PROPOSED CHANGE NO. SC-01-002R1

Date: July 24, 2025
File: 9.1.7.4.2_SC-01_PC
Project No.: 2215C
Project: TA Blakelock HS Reno - Phase 3
Subcontract: SC-01 General

Description: Elevator 2 (drama area)

CONTEMPLATED CHANGE NOTICE No. S1

4 SECTION - ELEVATOR AT STUDENT ENTRANCE
A104 1:50

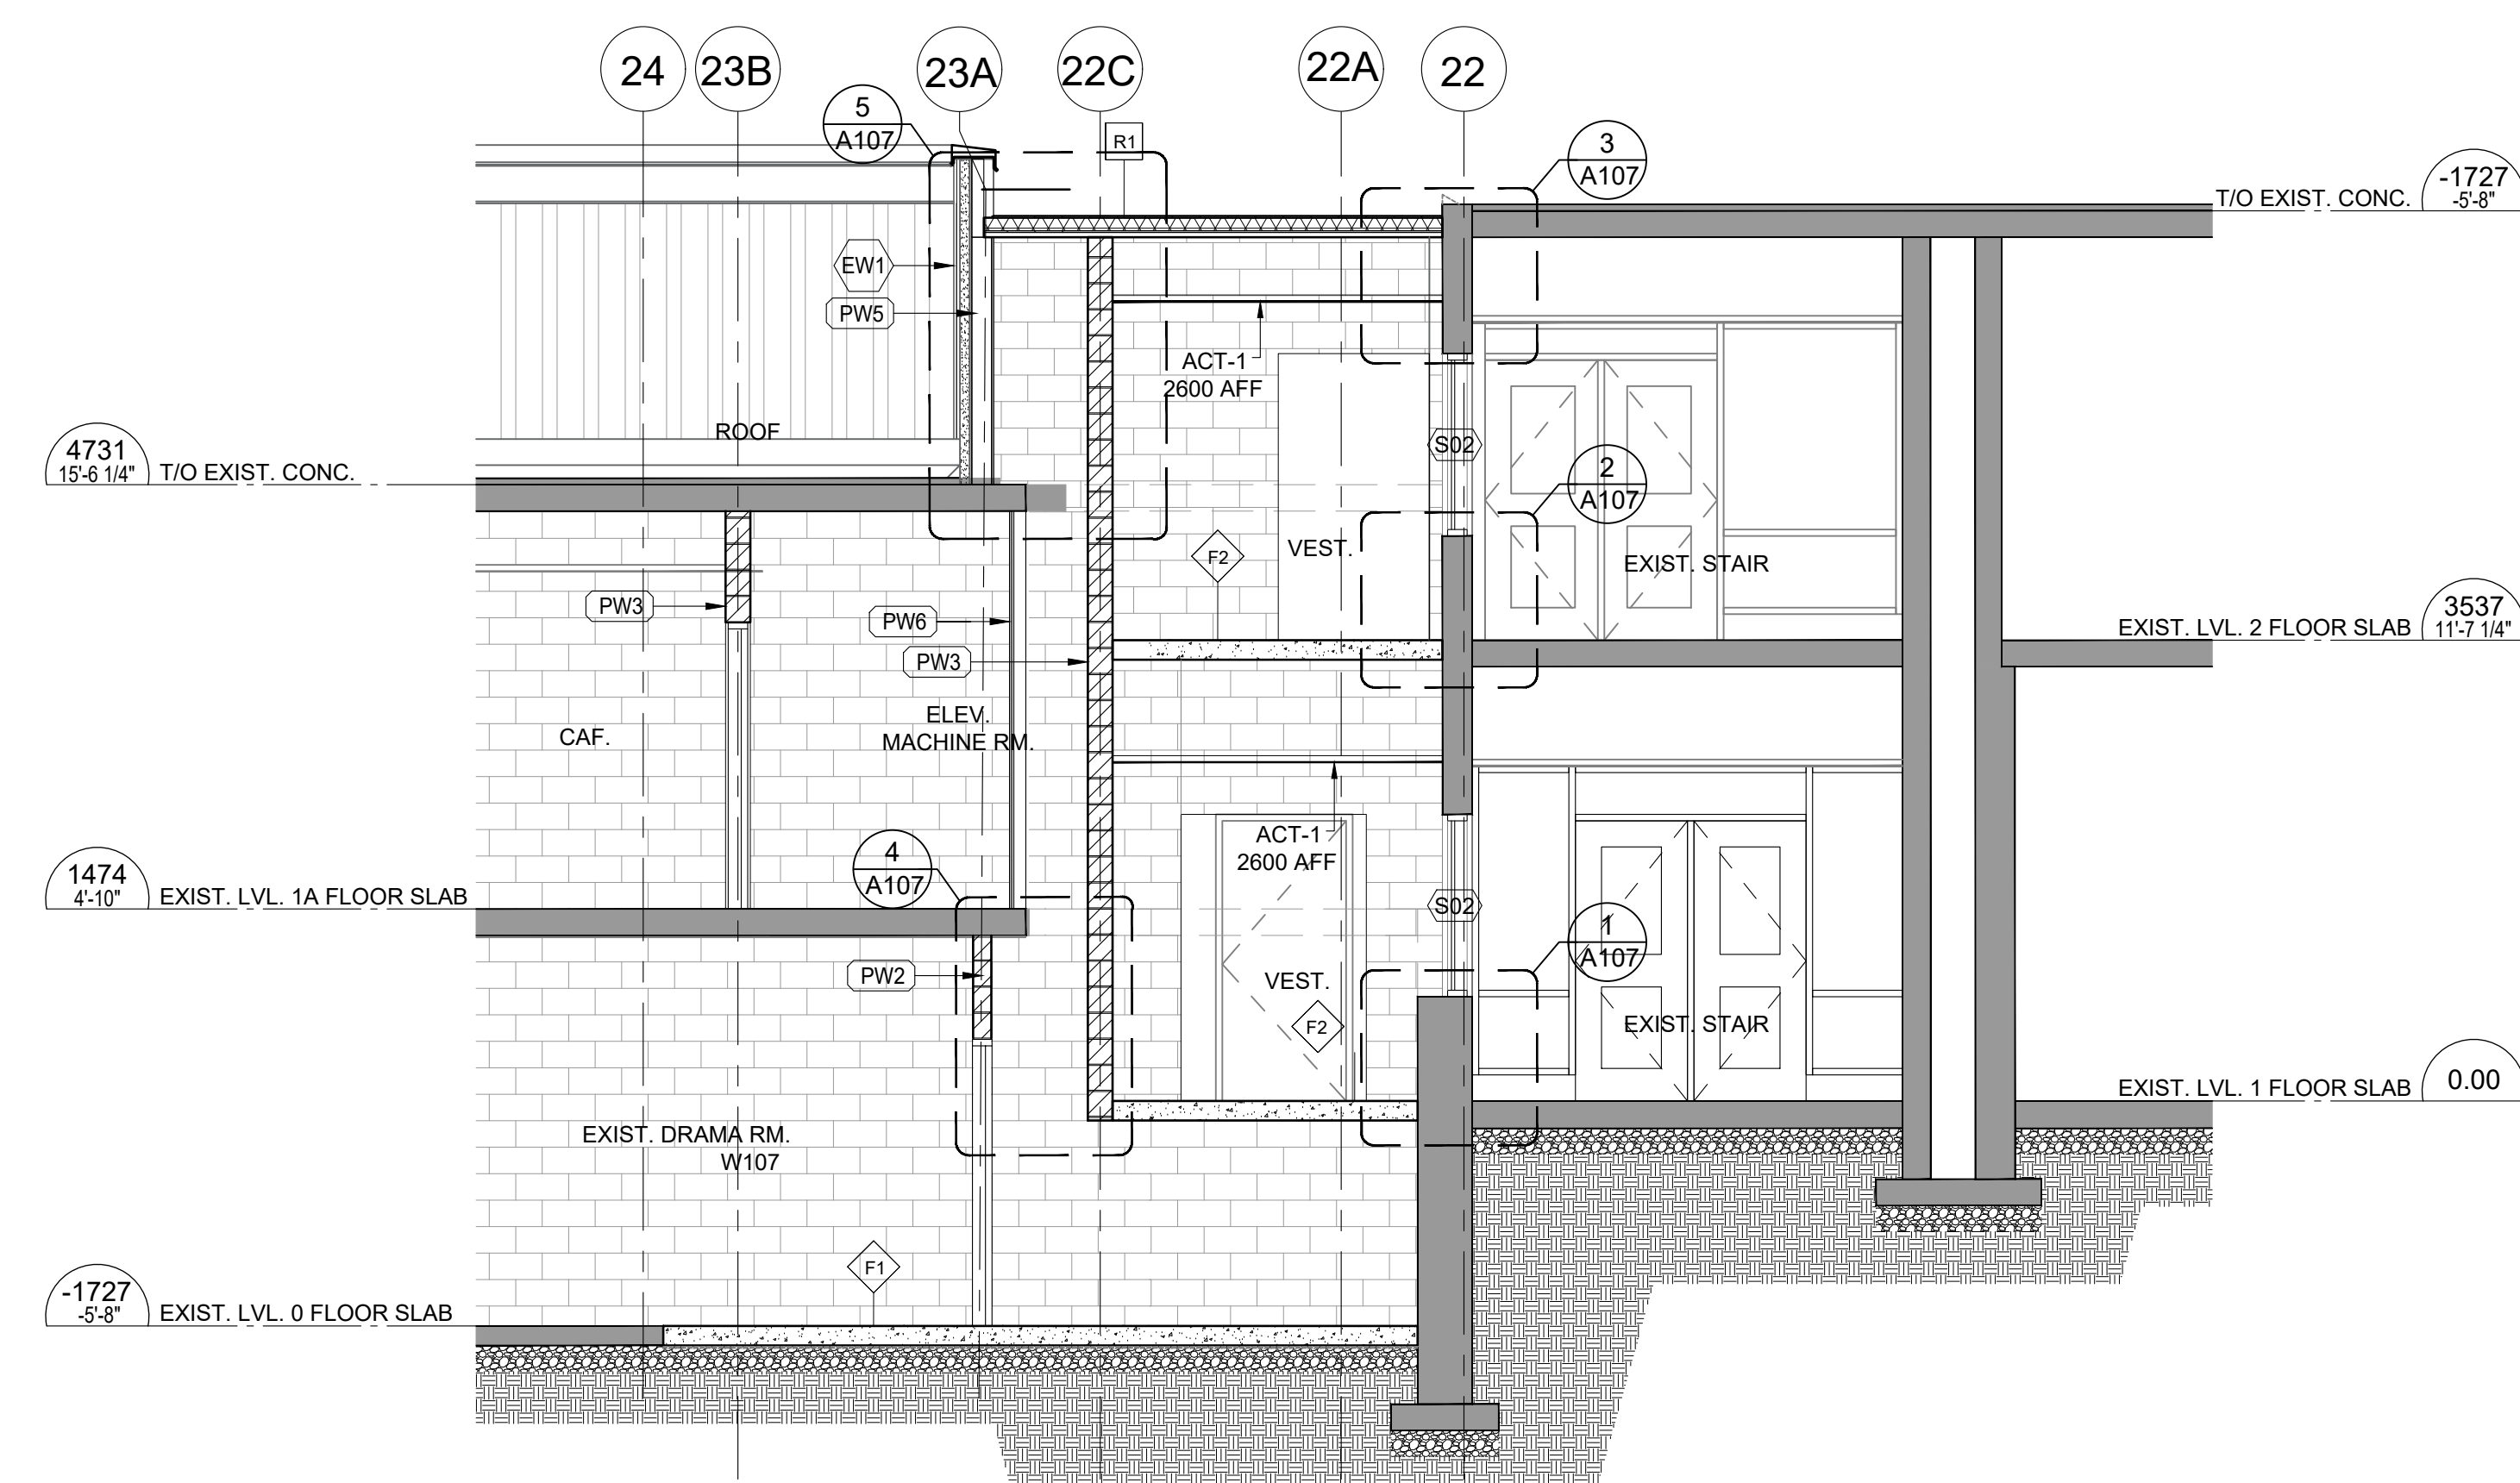
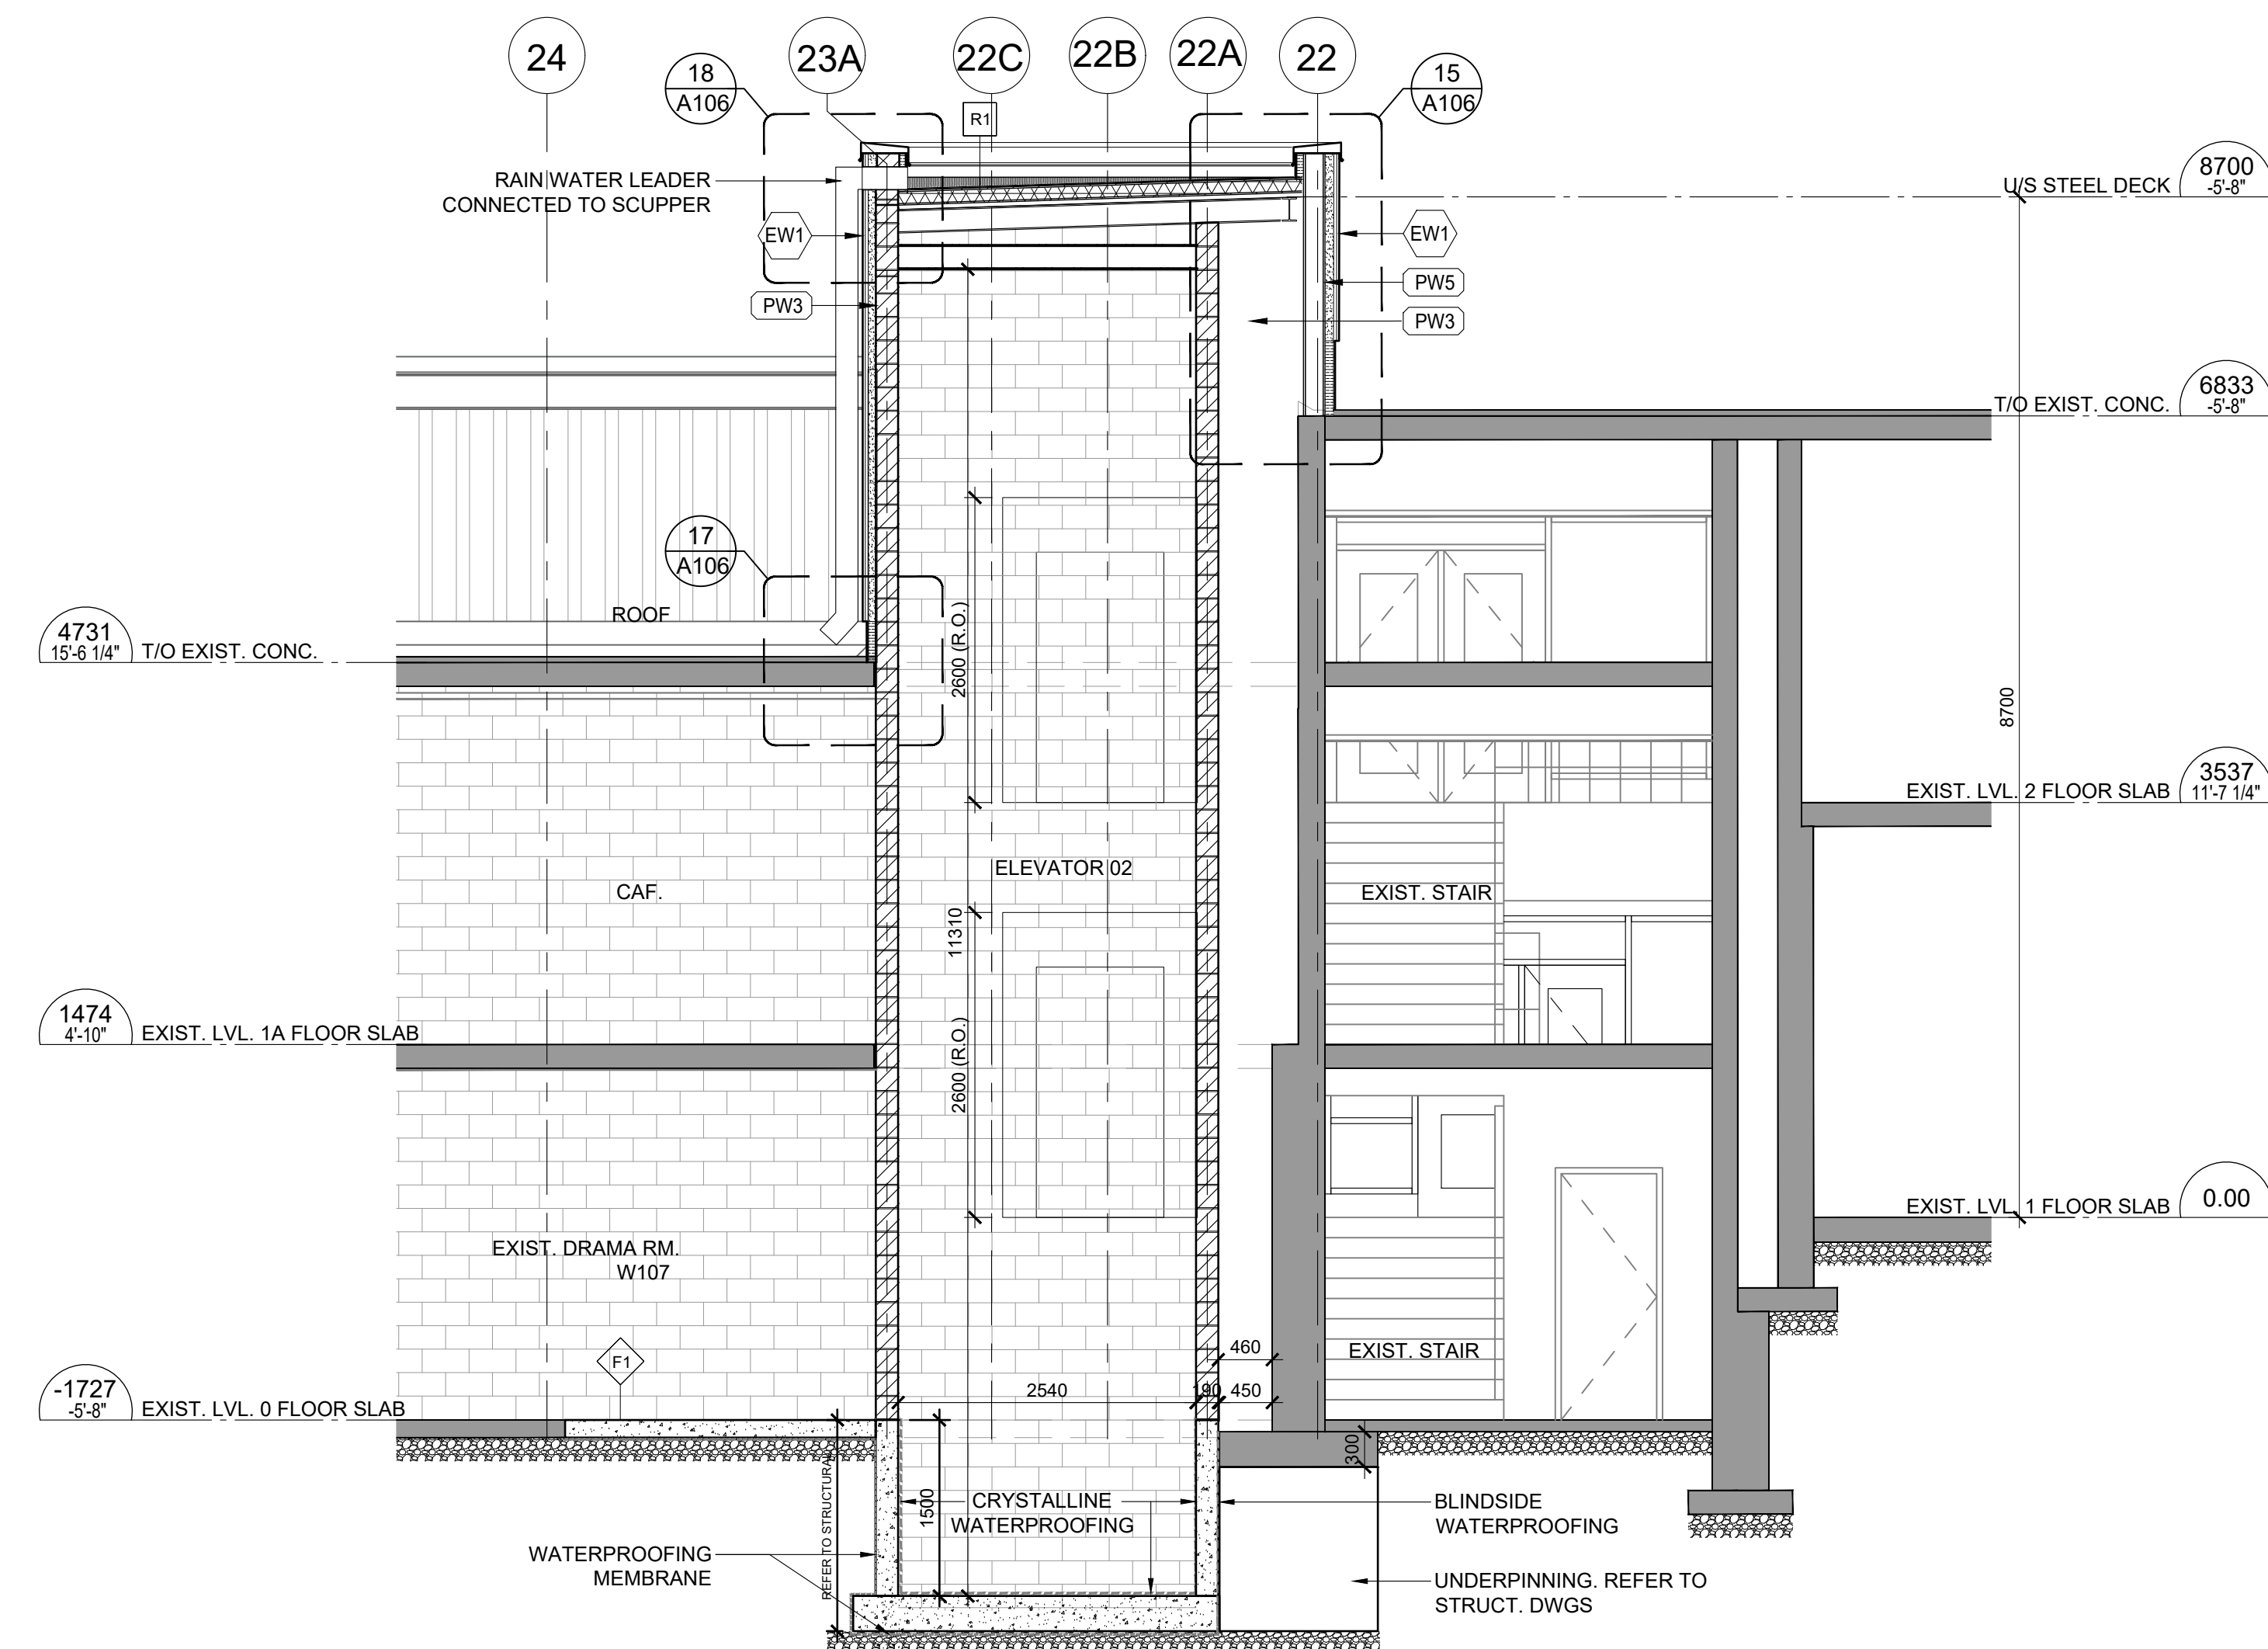
1. Refer to attached updated A100 floor plans and A104 updated sections.
2. Refer to Structural CONTEMPLATED CHANGE NOTICE No. S1 item 1 for requirements.
3. Mechanical CCN to follow adjusting sump pit location and corresponding drainage and piping to it. Electrical CCN to follow confirm power and control until location for sump pit.
4. Refer namely to sump pit relocation, deletion of underpinning along West side of Drama Room (Refer to Structural CCN for scope).
5. Provide 36x 36 ACUDOR FT-8050 concrete floor door, single leaf, 1" recessed to receive flooring. Provide cut sheet. Note this ACUDOR is intended to clear the 24" dia sump pit including sump pit flange. Confirm with vendor. Set sump pit lid just at u/s of lid opening. Provide cut sheet of ACUDOR. Run sump pit venting and discharge line within adjacent 190mm CMU wall.
